**SUBDIVISION COMMITTEE
METROPOLITAN AREA PLANNING COMMISSION**

**STAFF REPORT
(Preliminary Plat)**

CASE NUMBER: S/D 89-68 - BILL BAILEY 2ND ADDITION

Re: S/D 89-68 BILL BAILEY 2ND ADDITION

PRELIMINARY PLAT

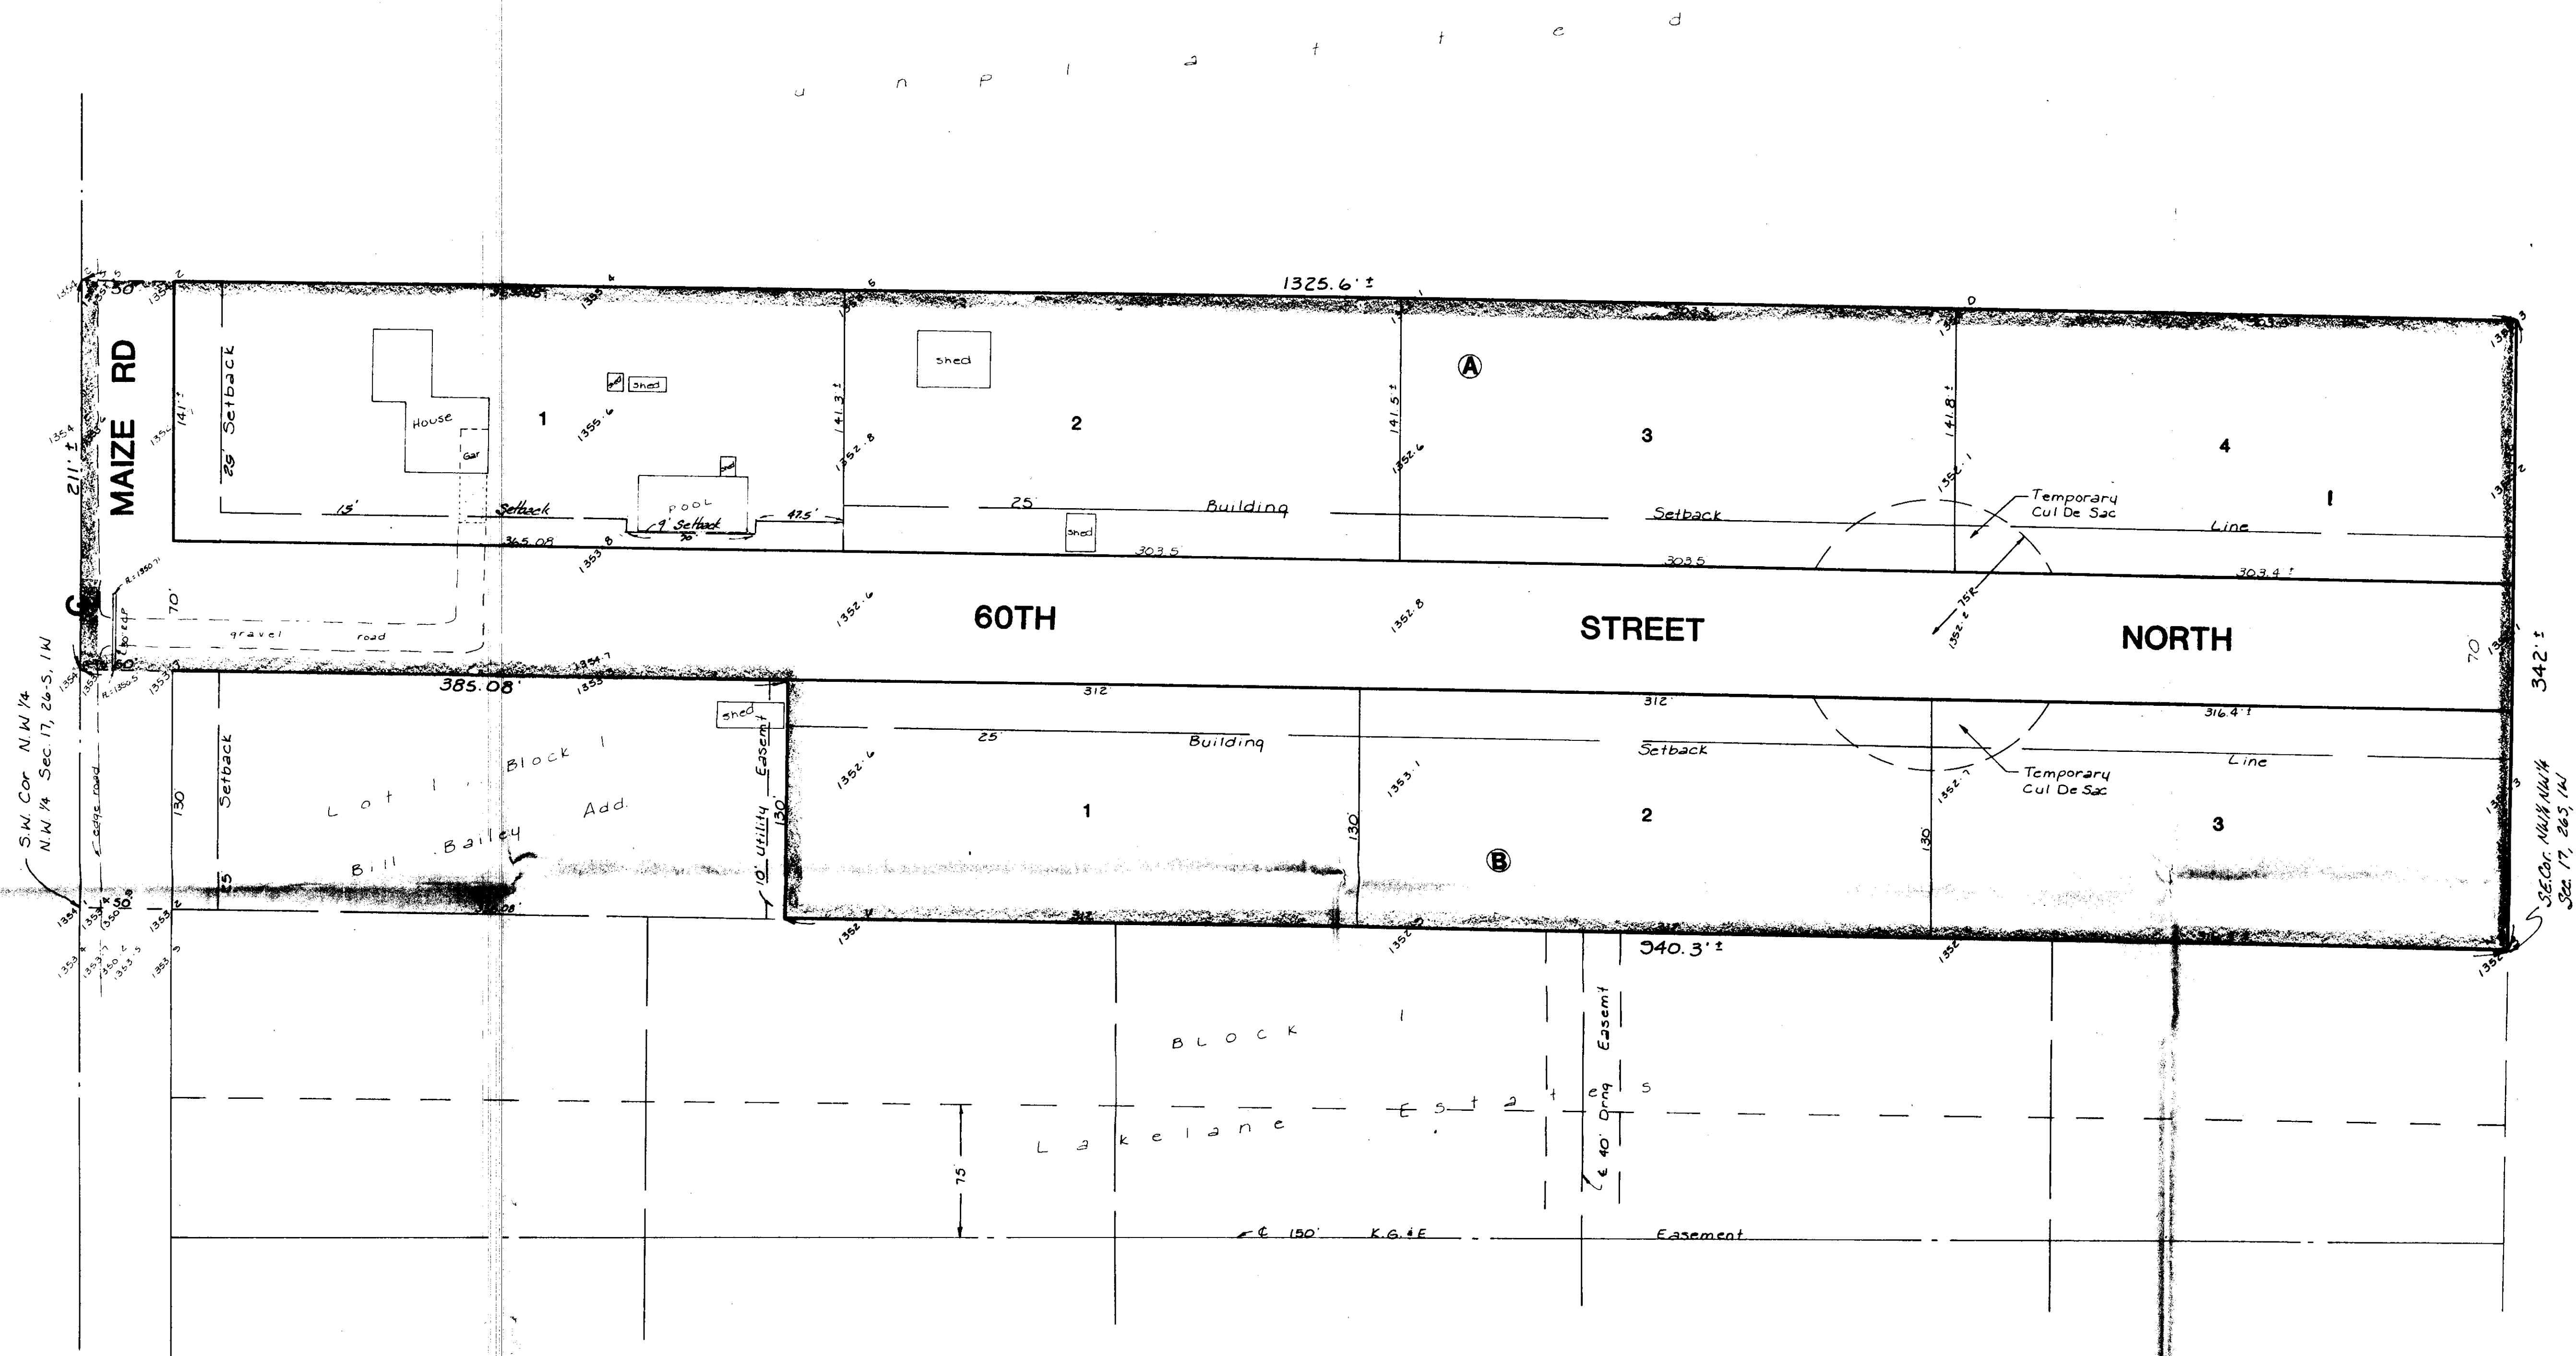
- A. In order to plat lots this size, the applicant must obtain "R-1" suburban residential zoning. An application for a zone change from "R" to "R-1" shall be submitted and approved prior to this plat being submitted to the County Commission.

- B. Since neither municipal water nor sanitary sewer is available to serve this property, the applicant shall contact the Environmental Health Division of the Health Department to find out what tests may be necessary and what standards are to be met for approval of on-site sewerage facilities and water wells. A memorandum shall be obtained specifying approval.

- C. The applicant shall guarantee the opening up of 60th Street North, including the temporary cul-de-sac, to suburban street standards.
- D. If improvements are guaranteed by petition, a notarized certificate listing the petitions shall be submitted to the Planning Department for recording.

- E. On the final plat complete access control shall be indicated to Maize Road from the west line of Lot 1, Block A. The plat's text shall state that the access control is being dedicated to the County.

- F. Lot 1, Block B shall also establish a 25-foot building setback to 60th Street. As indicated above and by the sketch plat, access to this site is by way of the proposed street. This setback maybe jogged around the existing pool.

- G. On the final plat tracing the cul-de-sac shall be indicated as temporary and the platator's text shall indicate that this temporary cul-de-sac will be vacated when 60th Street North is extended east.

- H. If required by the drainage plan, a floodway shall be indicated for this plat and the platator's text shall reference the standard floodway language.

- I. As required by section 8-103(1), the final plat shall indicate the placement of irons at all corner's of this subdivision. A legend shall be added to the face of the plat which identifies the irons set and the irons found.

- J. Prior to, or at the time of submitting the final plat, the applicant shall submit a drainage plan to County Engineering for review and approval.
 - K. To receive mail delivery without delay, and to avoid unnecessary expense, the applicant is advised of the necessity to meet with the U.S. Postal Service Growth Management Coordinator (phone 316-946-4527) prior to development of the plat so that the type of delivery, and the tentative mailbox locations can be determined.
